## 1 Products affected

Product hierarchy no. *			Part no.	SBU	Type / Description	Customer part no.
SBU   PG	PGU	Type				
90 004	004	0000001008	See list below	Voltage Selector	SWM1	
90 004	010	0000001009	See list below	Voltage Selector	SWM2

SWM					0118.2287	
creation date	created by	release date	released by	notification no.	revision	page
2015-05-11	helblijo	2015-12-03	schaidro			1 of 3

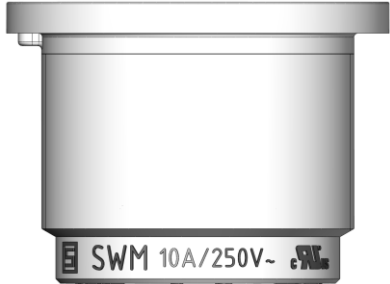
1. Modification of approval marks
2. Material changed on the selector disc

Old marking	New marking
UL	cURus
CSA	cURus
VDE	ENEC10
T85	40T85
6.3/250V	6.3/250V~
10/250V	10/250V~
Semko	-
SEV	-

Old material		New material
E41938	UL-Filenumber	E340012
PBT / Polybutylene Terephthalate	Materialtype	PA66 / Polyamide 66

1. New Approval mark by ENEC10  
 Consolidation of North American approval marks with the combined cURus mark.
2. Change of the material, in order to improve the mechanical properties
